**OHIO TURNPIKE AND
INFRASTRUCTURE COMMISSION**

ADDENDUM NO. 3

**PROJECT NO. 43-17-05
BRIDGE DECK REPAIR AND REHABILITATION
BOSTON MILLS ROAD OVER OHIO TURNPIKE M.P. 178.0,
OLDE EIGHT ROAD OVER OHIO TURNPIKE M.P. 179.5,
NICHOLS ROAD OVER OHIO TURNPIKE M.P. 199.2,
SUMMIT AND PORTAGE COUNTIES, OHIO**

MODIFICATION TO PLAN SHEETS 2, 8, 12, 18, 32, 39 AND 44

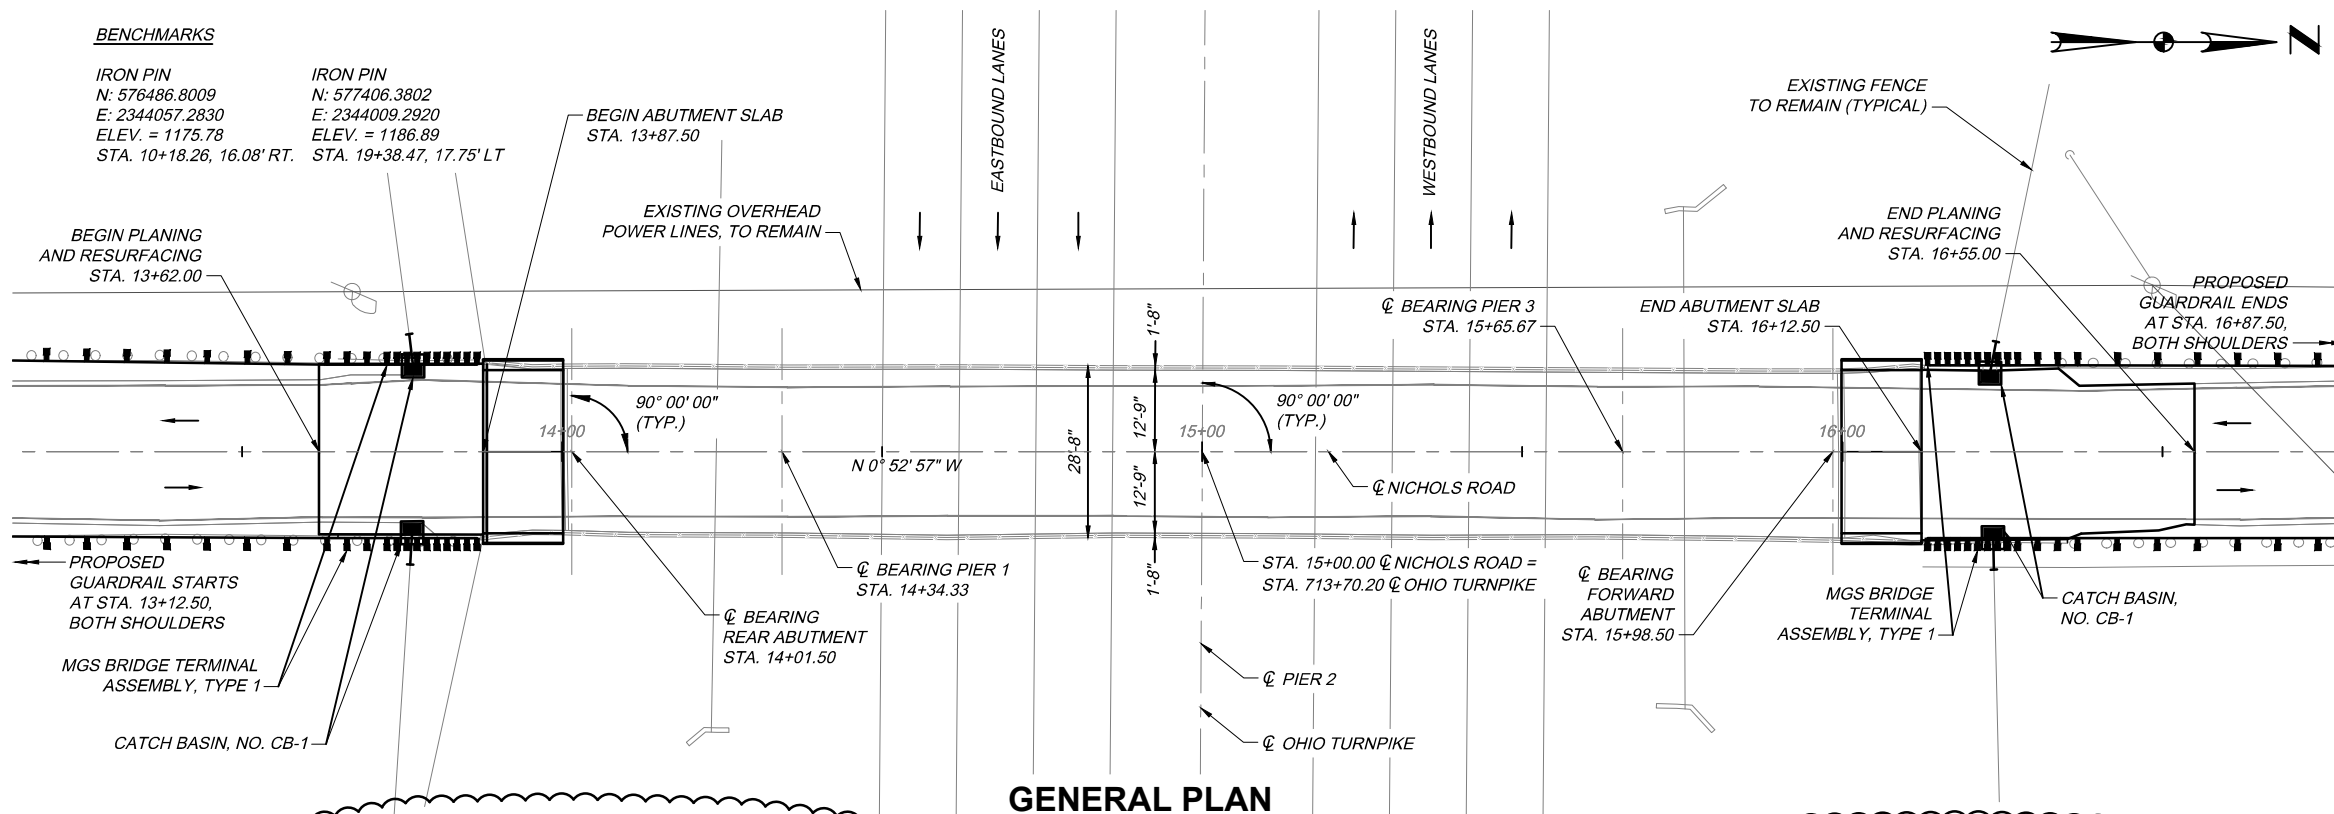
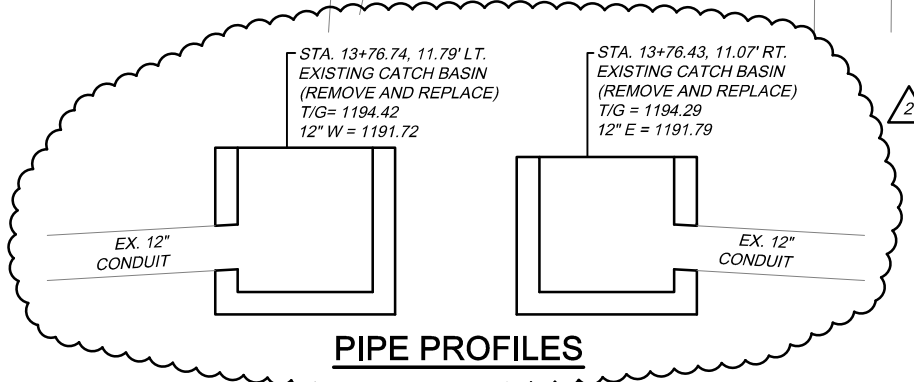
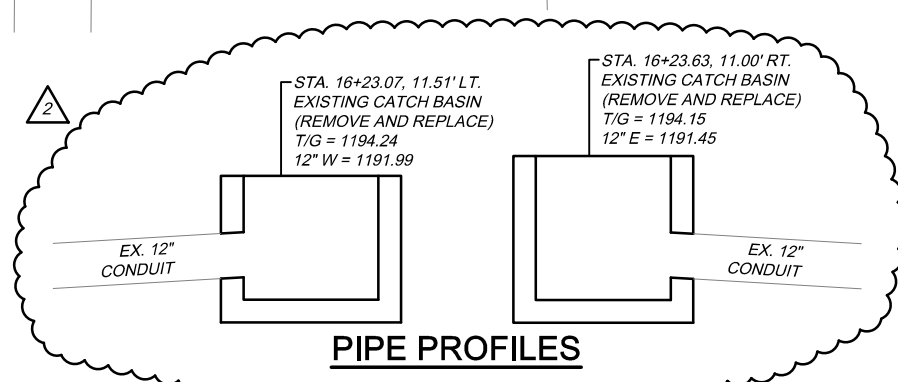
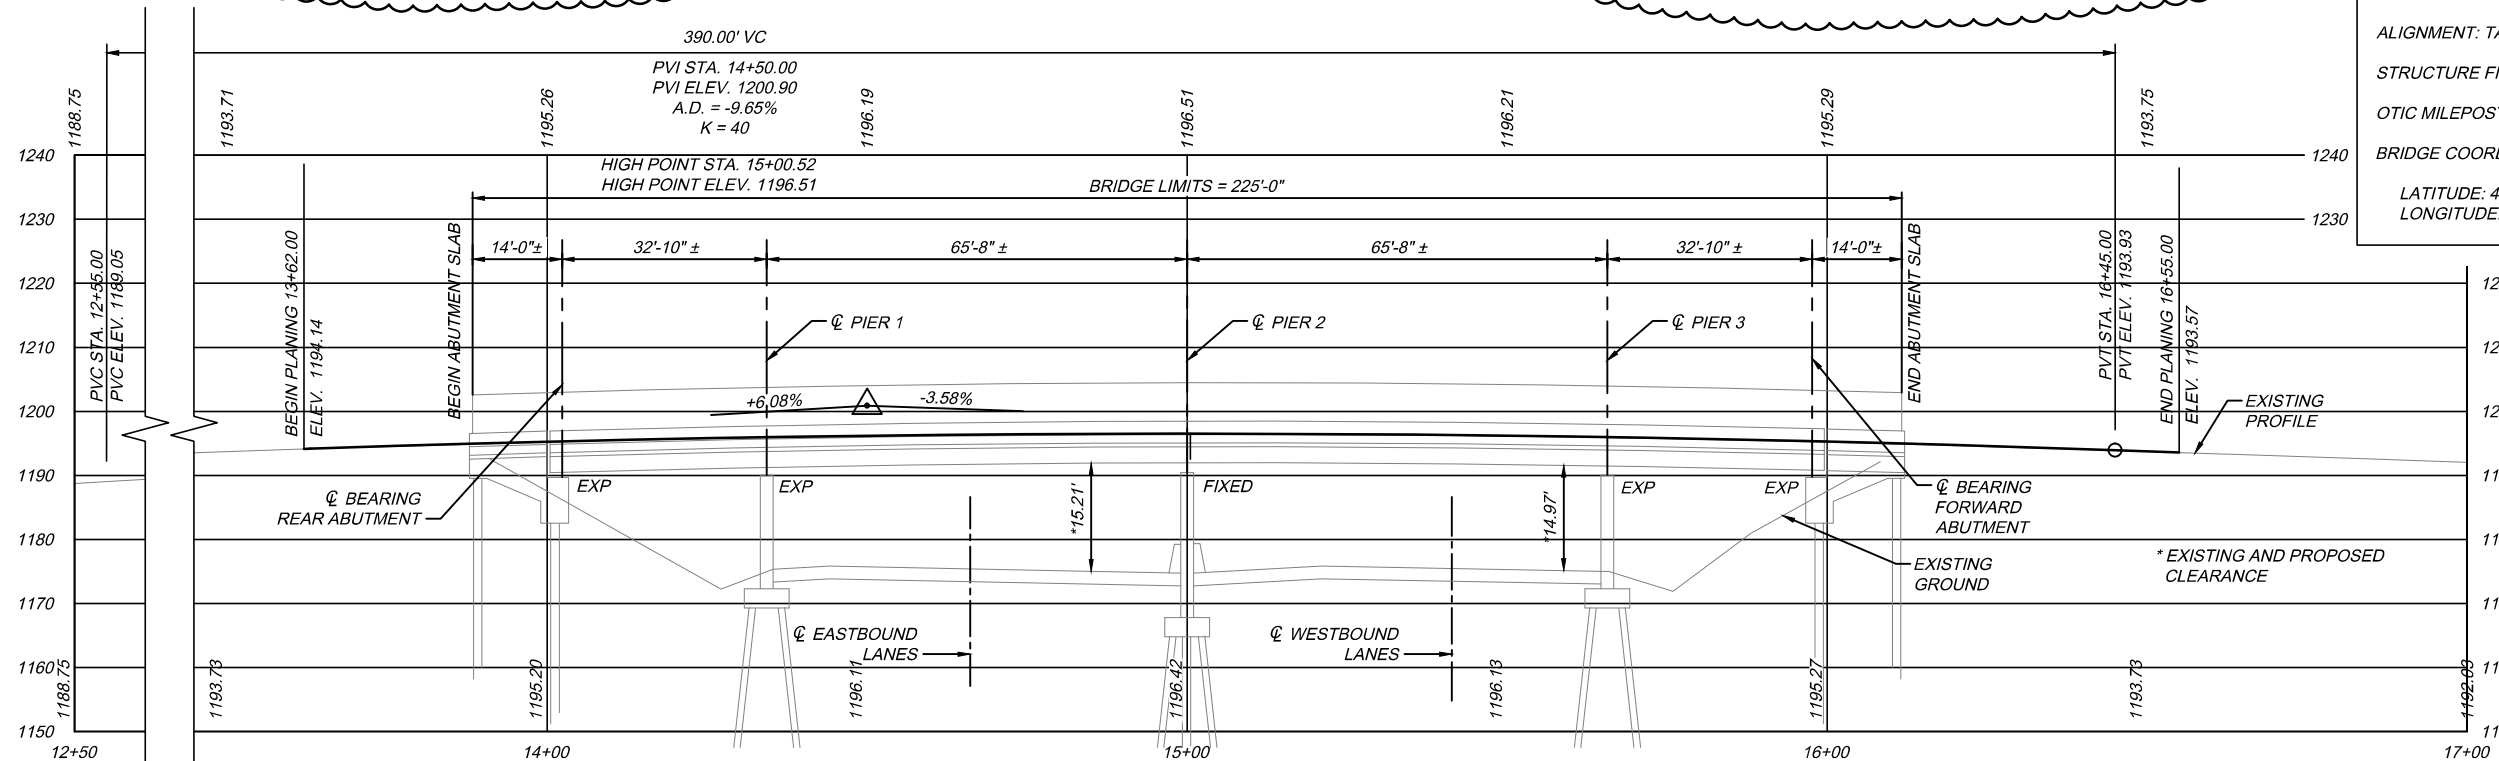
Q#8 The four (4) existing catch basins at Nichols Road are called out to be “reconstructed to grade” on plan sheet 39/49. The General Summary on plan sheet 2/49 indicates that the four (4) catch basins at Nichols Road are to be removed by bid item #8 and replaced with new catch basins by bid item #24. Also, there is a general note on plan sheet 8/49 “SP604 – Catch Basin Reconstructed to Grade” that describes the work involved with the reconstruction activity. It is unclear as to what the OTIC intends to do with the four (4) catch basins at Nichols Road. Please clarify if these catch basins are to be removed and replaced according to the General Summary or reconstructed and adjusted to grade according to plan sheets 8 & 39/49 and adjust the existing bid item quantity and add the new bid items if reconstruction is the desired work.

A#8 All catch basins at Nichols Road are to be removed and replaced. Plan Sheets 8 and 39 of 49 are revised accordingly through this Addendum No. 3.

SHEAR STUD DETAILS
NICHOLS ROAD OVER OHIO TURNPIKE
PORTAGE COUNTY
M.P. 199.2

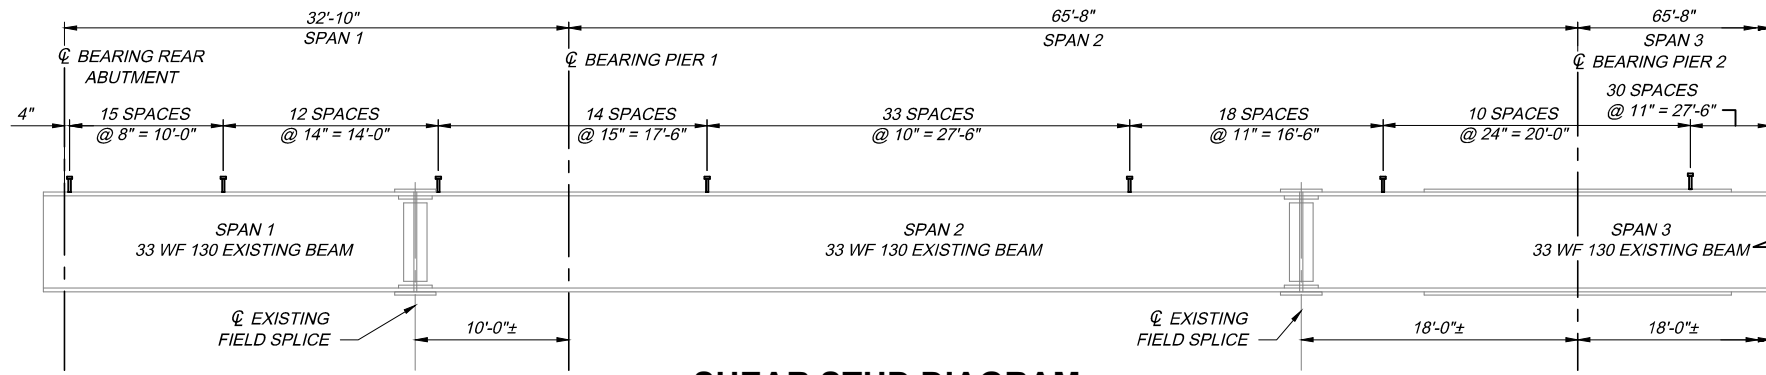
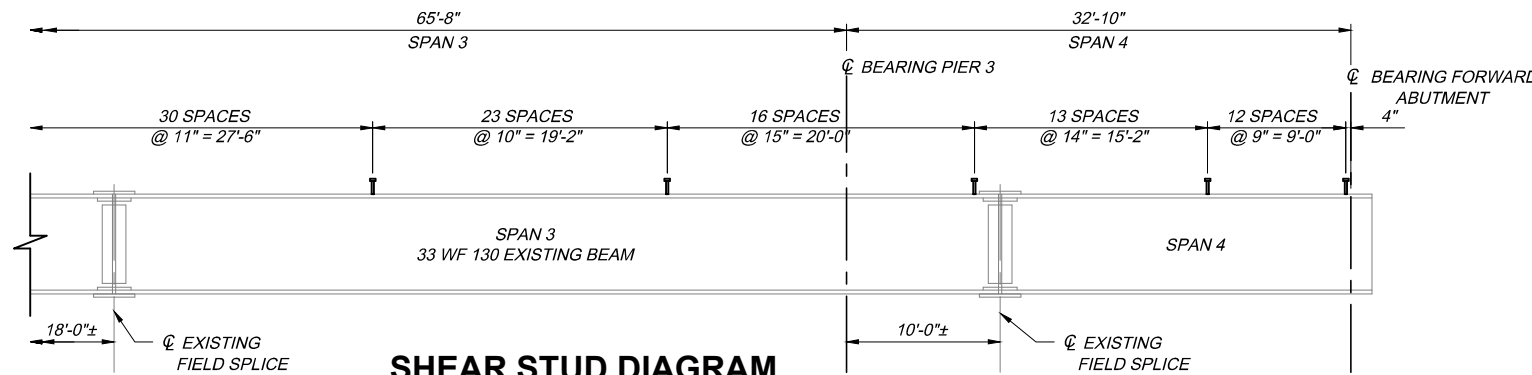
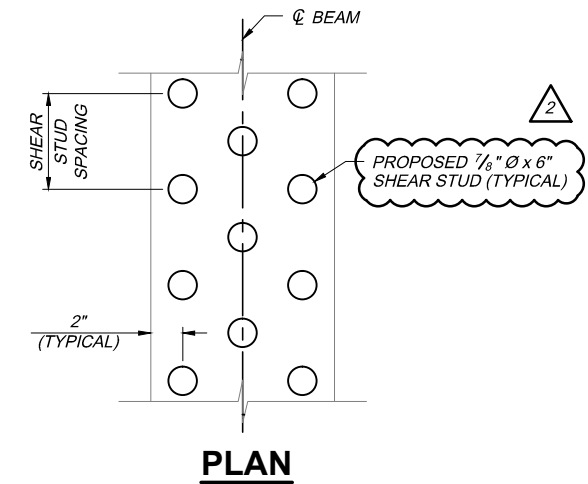
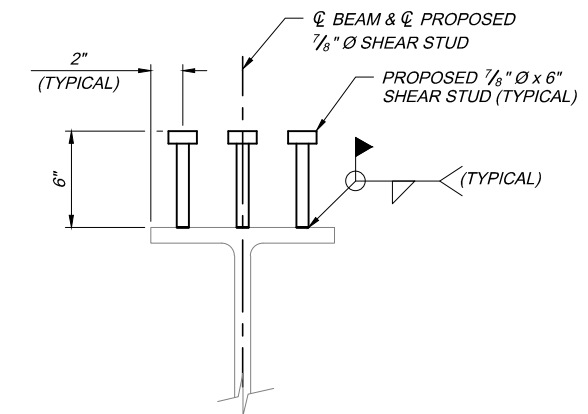
Q#13 Plan Sheet 44/49 it calls out the shear studs as 7/8" x 6" in the elevation view and then as 7/8" x 5" in the plan view. Can the correct stud length please be provided?

A#13 Six (6) inch studs are to be provided, and Plan Sheet 44 of 49 is revised accordingly through this Addendum No. 3.
